SUBJECT: Response to Request for Additional Information
Concerning the Spring 2014 Steam Generator Inspections
Arkansas Nuclear One – Unit 2
Docket No. 50-368
License No. NPF-6

**RESPONSES TO REQUEST FOR ADDITIONAL INFORMATION
CONCERNING THE SPRING 2014 STEAM GENERATOR INSPECTIONS**

S/G A
 COLD
 PRIMARY FACE

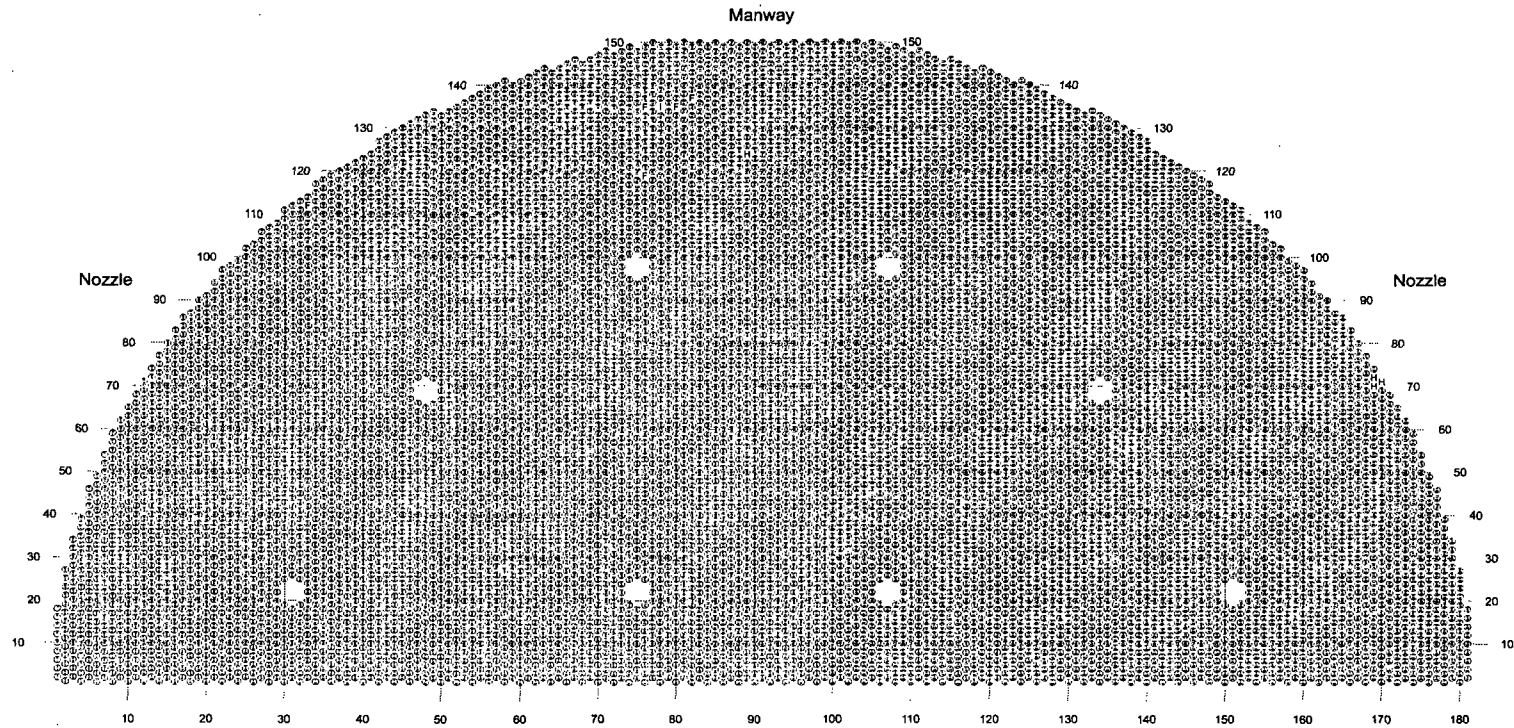
Please provide a tubesheet map so the NRC staff can better understand the locations of the indications. In addition, please provide the thickness of the tubesheet with and without cladding.

Please refer to the ANO-2 tubesheet map included in this letter. The tubesheet is a forged carbon steel plate with cladding installed on the primary side.

Tubesheet thickness without the clad	31.13 inches
Tubesheet cladding thickness	0.43 inches
Tubesheet thickness with clad	31.56 inches
